US Department  
of Transportation  
**Federal Highway  
Administration**

Refer to: HMHS-B37A

In your October 12 letter, you requested the Federal Highway Administration's (FHWA) acceptance of two transition designs. "These designs will be used to connect a standard box beam approach guardrail to two Wyoming Department of Transportation bridge railing designs that were accepted for use on the National Highway System in Mr. Seppo Sillan's July 1, 1998 memorandum to Mr. Vincent Schimmoler. Mr. Schimmoler was the FHWA Regional Administrator in Denver at that time. Included with your request were two copies of the September 1999 Texas Transportation Institute report, "NCHRP REPORT 350 TESTING AND EVALUTAION OF THE WYOMING TL-3 AND TL-4 BRIDGE RAIL TO BOX BEAM GUARDRAIL TRANSITION DESIGNS," by Mak, Buth, Bligh, and Menges, and videotapes of the crash tests you conducted to verify acceptable impact performance.

CONNECTION TO TL4 STEEL  
BRIDGE RAILING

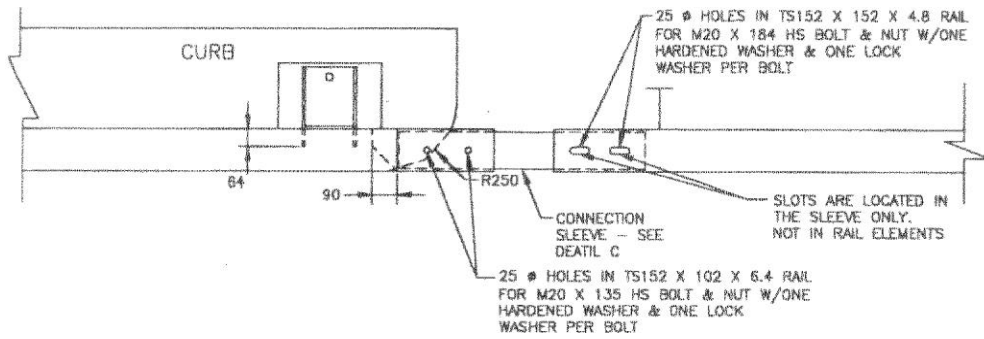
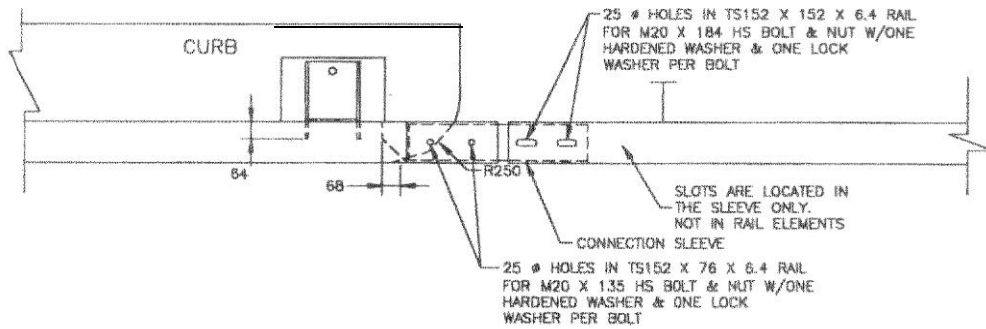
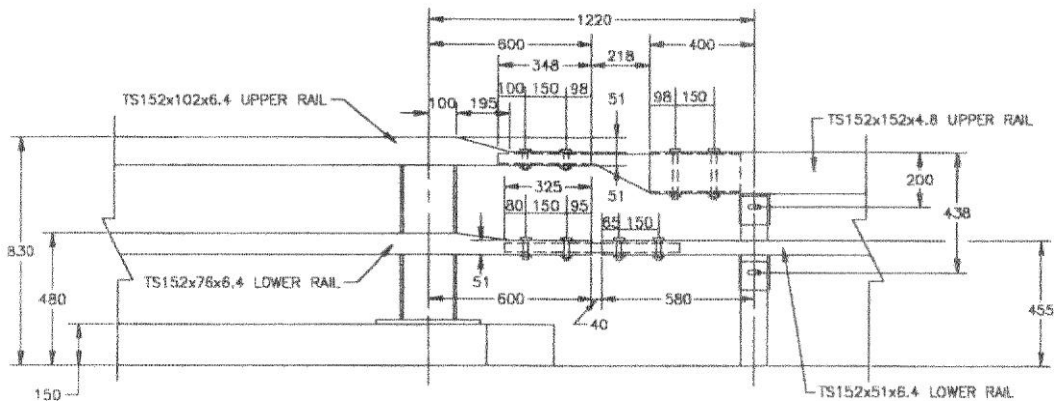
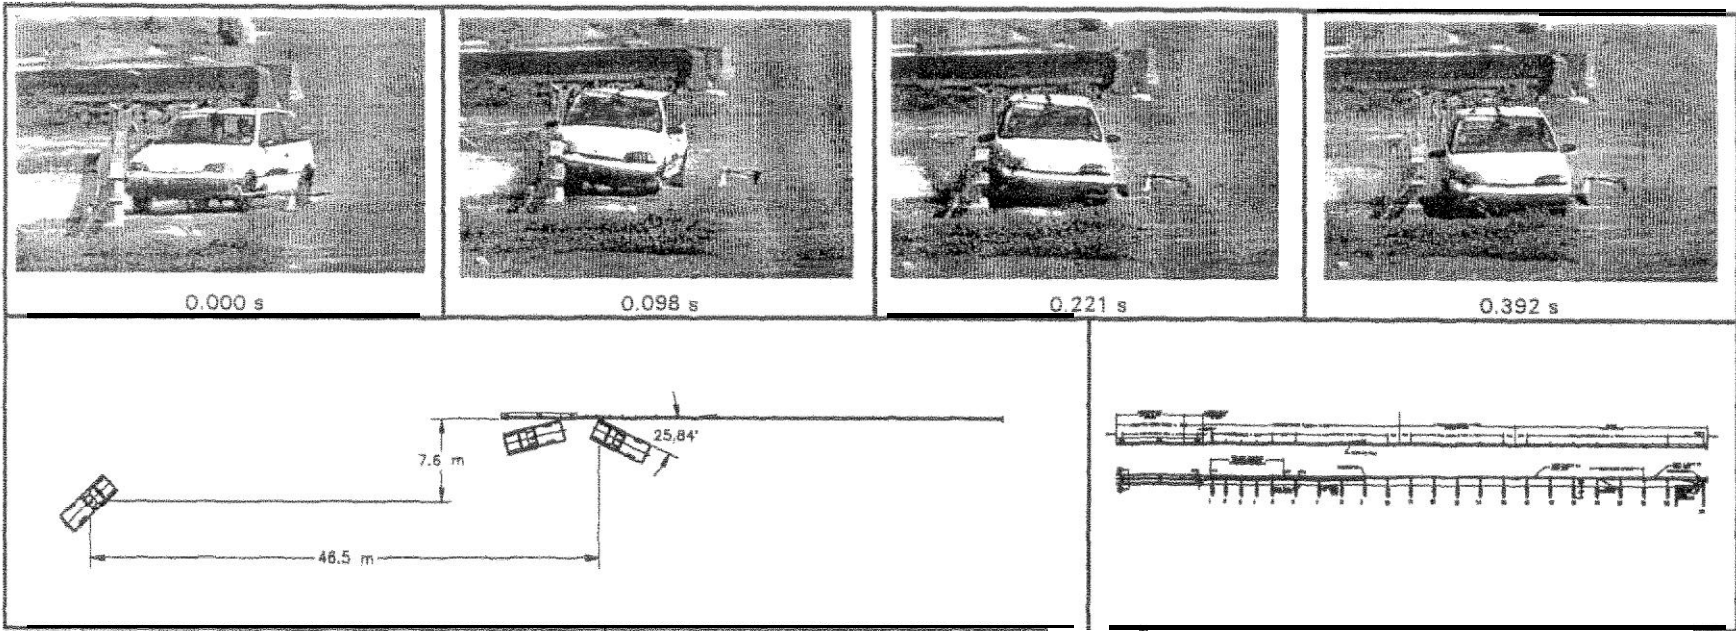
Both transition designs use the same components to the extent practical, the only significant differences being the connection details at the bridge railings and adjustments to the mounting heights to match the two different bridge railing designs. These details are shown in Enclosure 1. The ground-mounted post sizes and spacing are the same for both transitions, i.e., five W150 x 13 (W6 x 9) x 1625-mm (till-inches) steel posts with soil plates on 1220-mm (4-foot) centers, one same-size post at 1830 mm (6-feet), followed by standard S75 x 8.5 ( x 5.7) box beam line posts on 1830-mm (h-foot) centers. The lower bridge rail element for both bridge railing designs is continued off the bridge to serve as a rub rail until it is terminated behind the ninth guardrail post off the bridge.

Finally, you stated that minor changes were made to the TL-4 bridge railing design to accommodate the transition design. The most significant changes were the thickness reduction of the upper bridge rail element from 7.9 mm (5/16 inch) to 6.4 mm (1/4 inch) and the cross-section reduction at the ends of both the upper and lower bridge rail elements to match the connection sleeves. We concur with your assessment that these changes are not likely to lessen the performance of the TL-4 bridge railing. Please call Mr. Richard Powers of my staff at (202) 366-1320 if you have any questions or wish to discuss any of the above in more detail.

Based on our review of the information you submitted, we find that the two designs for attaching a standard box beam guardrail to the Wyoming Z-tube, curb-mounted TL-3 and TL-4 bridge railings meet the appropriate crash test evaluation criteria for NCHRP Report 350 test level 3 (TL-3) transitions. They may be used on the National Highway System when such use is requested by a State transportation agency. We understand that neither the bridge railing designs nor the transition designs are proprietary and that plans and specifications for both can be obtained directly from the Wyoming Department of Transportation.
